E4100B-02-S

S E R V I C E N O T E

HP E4100B PT500 Protocol Tester

PT BACK BEZEL GROUNDING WIRES UPGRADE

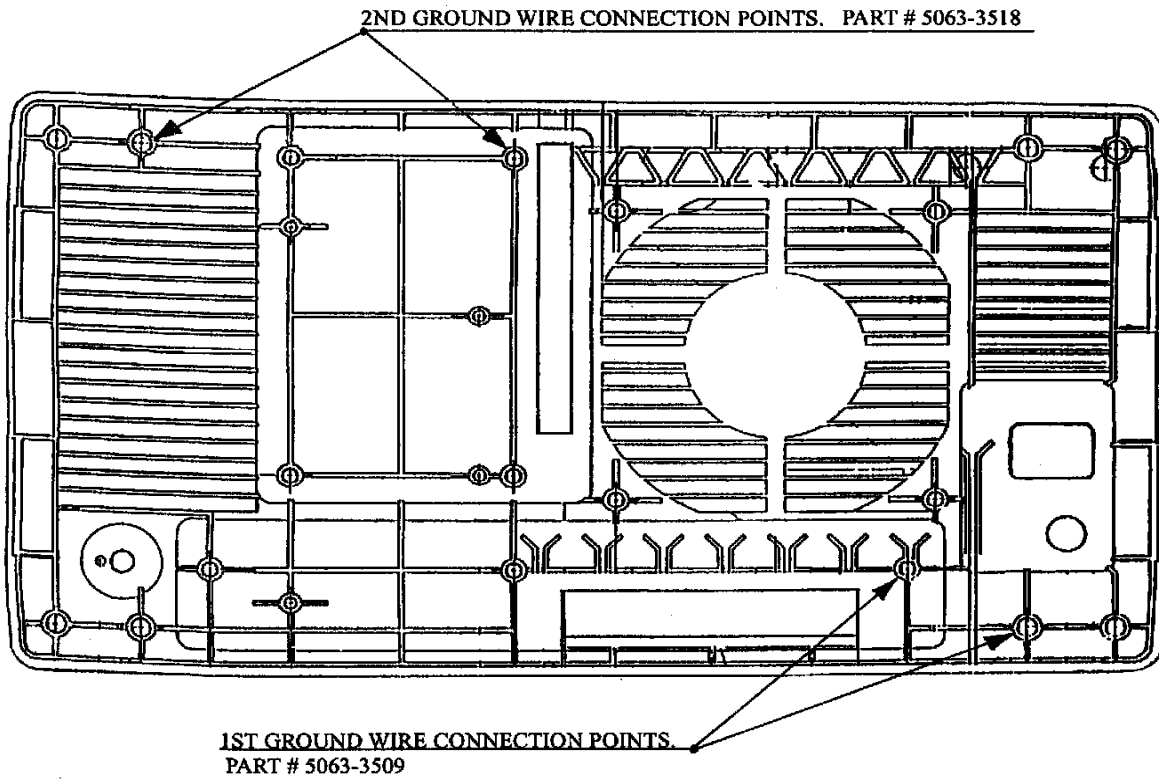
A situation exists in which a unit in the referenced serial number range could possibly become a shock hazard to personnel. This situation would likely only occur if high voltage is present on the connector module plane or connector module handle and the existing ground path was blown away. The existing ground path is insufficient to carry current specified by Hewlett-Packard safety requirements. This situation has occurred to date only when checking the unit with a megger or similar device.

Affected units must be retrofitted with grounding wires to rectify the problem, using the following instructions.

- Remove top cover of instrument and interface module.
- Install longer (11 cm) ground cable, p/n 5063-3518, to existing screw of upper left hand side member bracket hole.
- o Connect to inside connector module hole, beside degaussing board, with 4x5 screw.

- Remove bottom cover of instrument and auxilliary connector module.
- Install 8 cm ground cable, p/n 5063-3509, to right hand side hole of auxilliary connector with 4x5 screw.

- o Connector module handle should be grounded from the rear handle screw to the nearest DB style connector screw by installing one of the 5063-3510 wires between these two points.
- Use the four 4x28 screws to reinstall connector module.

- Applies only to MPT368.2, IPT468, XPE systems with no parallel printer connector, that is, with auxilliary connector module 4010-0070-IDA.
- Install grounding wire between the handle mounting screw and the nearest screw of the "PRINTER" connector.
- Reinstall auxilliary connector module using three 4x25 screws.
